CITY OF MISSION, KANSAS
COMMUNITY DEVELOPMENT COMMITTEE

WEDNESDAY, APRIL 4, 2018

RE: Tidal Wave Auto Wash Preliminary and Final Site Plan, 6501 Johnson Dr

STAFF REPORT
Planning Commission Meeting March 26, 2018

PROPOSED FLOOD PLAIN PLAN

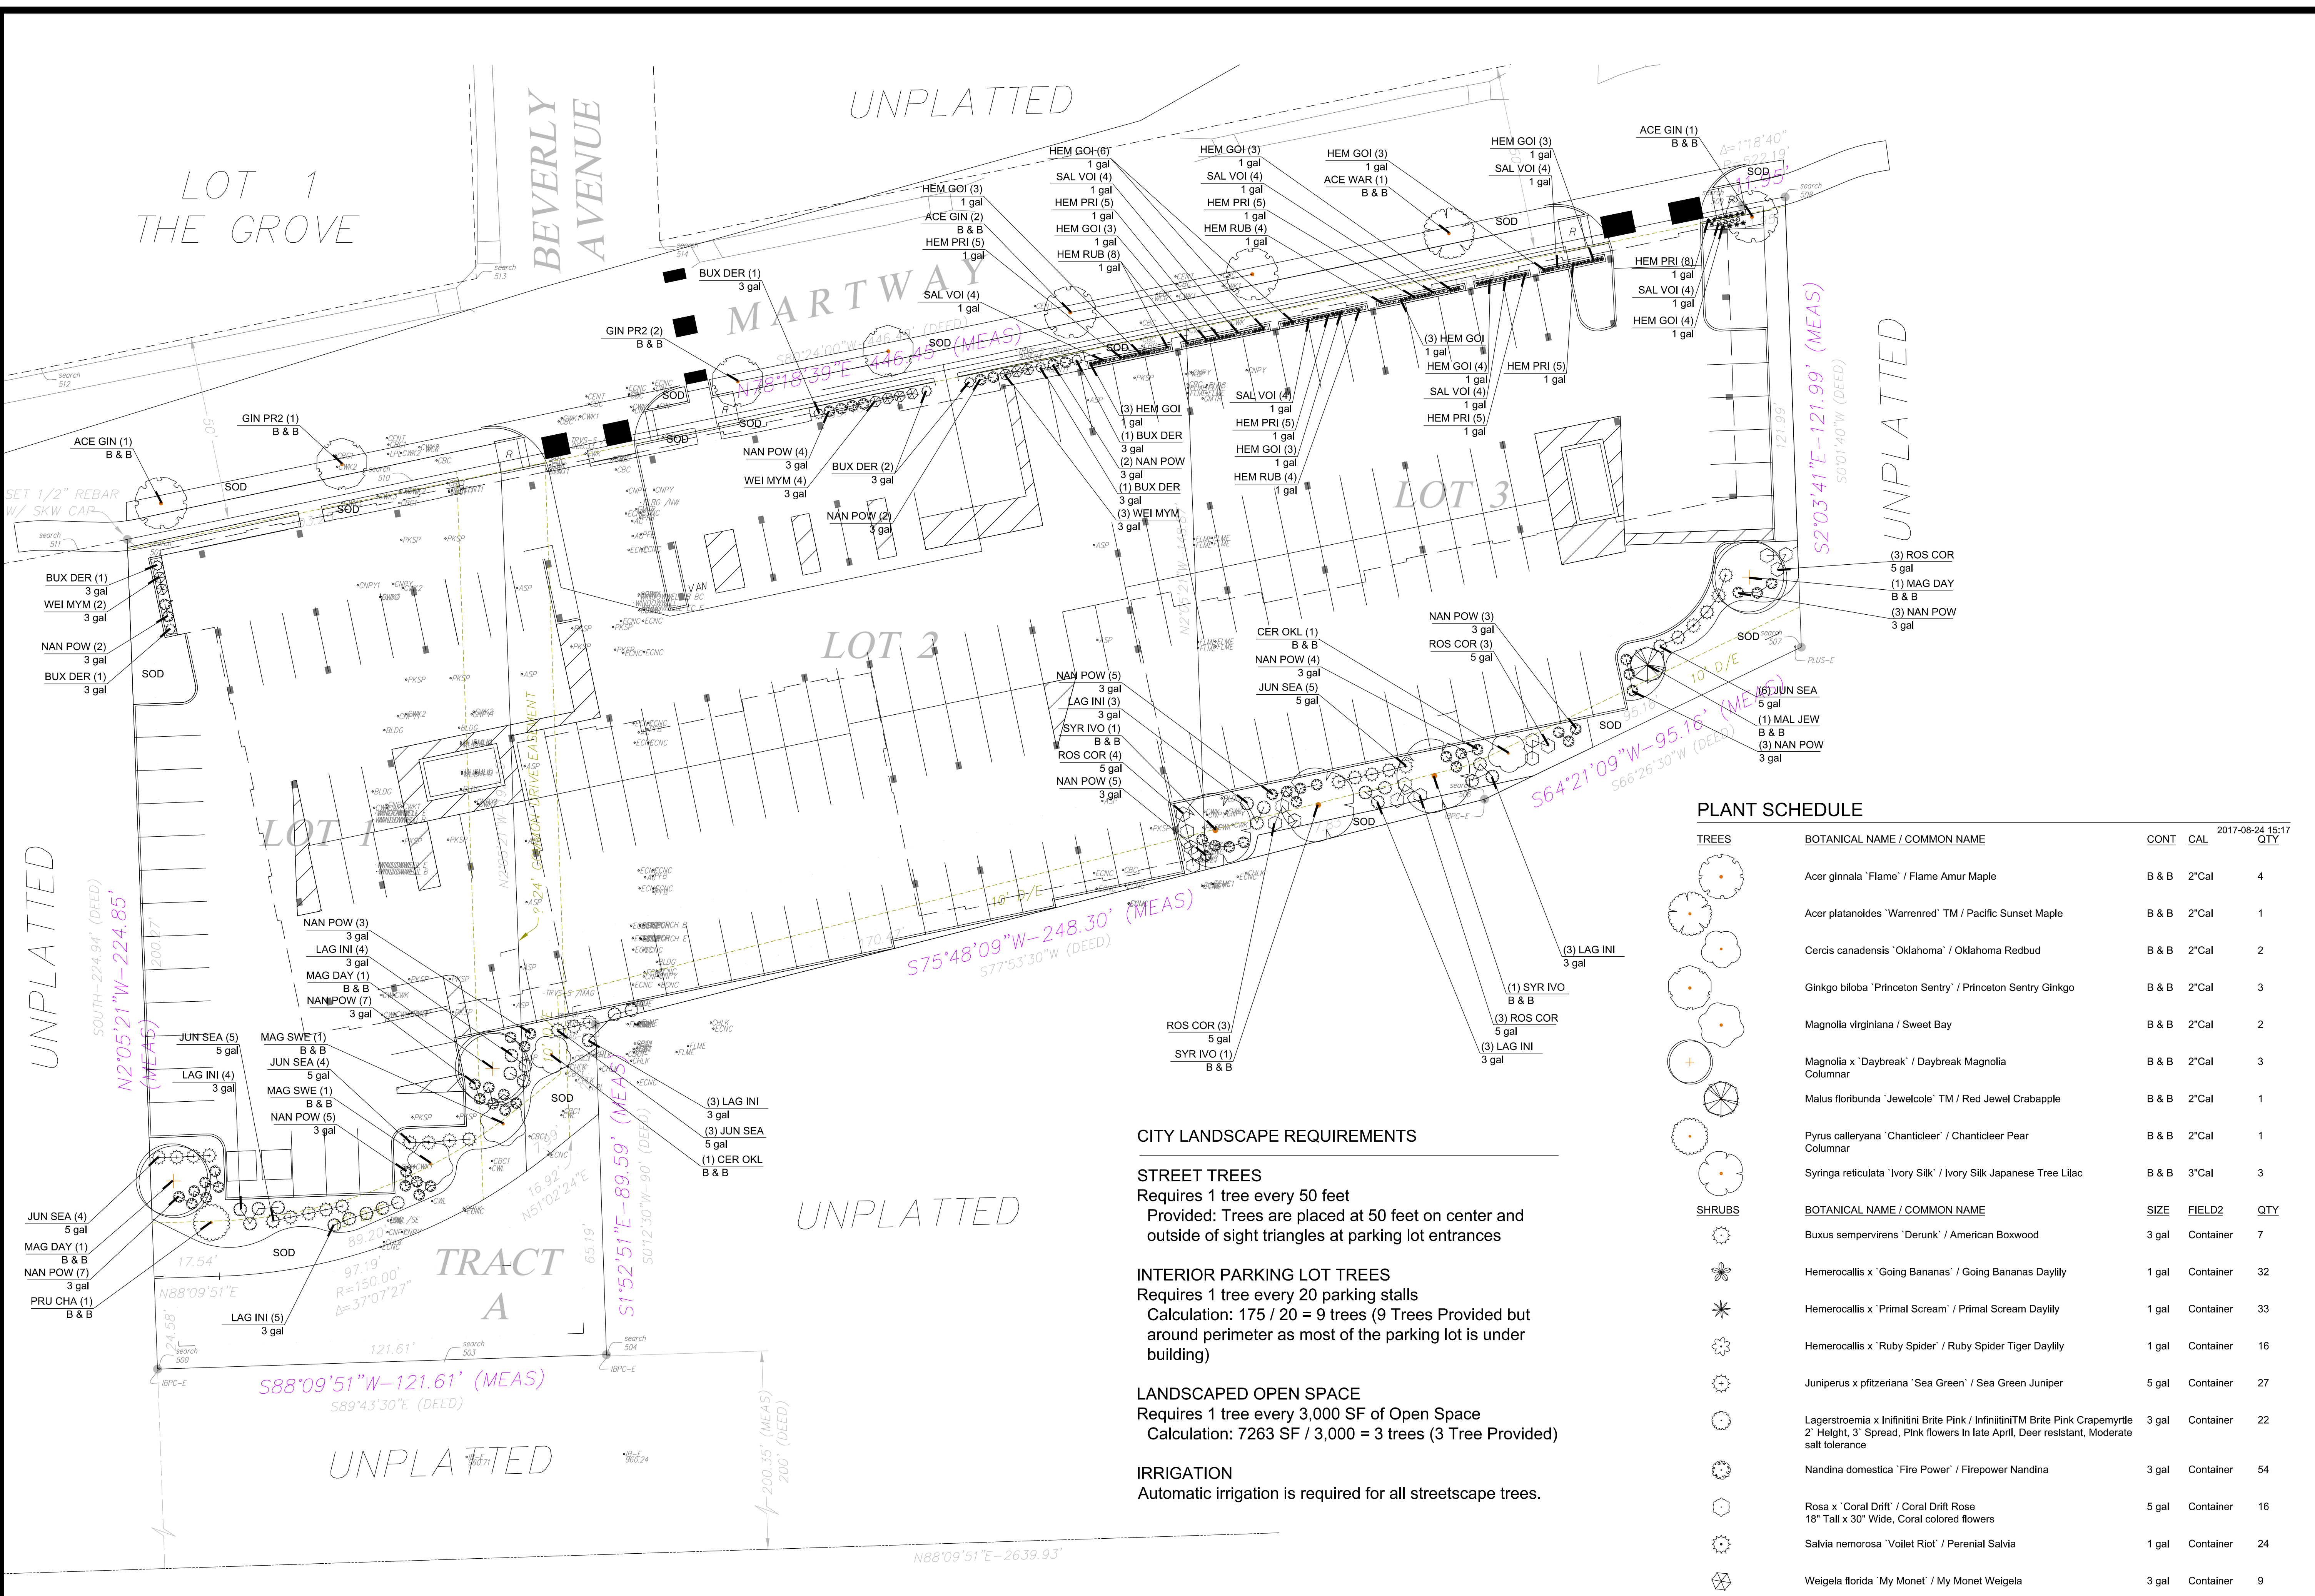
The 100 year floodplain limits over parking lot have been shown on Sheet C-203, Proposed Floodplain Plan. The parking lot has been graded such that no parking stall would pond over 7” based on the FEMA floodplain depths.

Both the traffic study and the drainage memo has been updated to address parking lot ponding. The 100 year floodplain limits over parking lot have been shown on Sheet C-203, Proposed Floodplain Plan. The parking lot has been graded such that no parking stall would pond over 7" based on the FEMA floodplain depths.
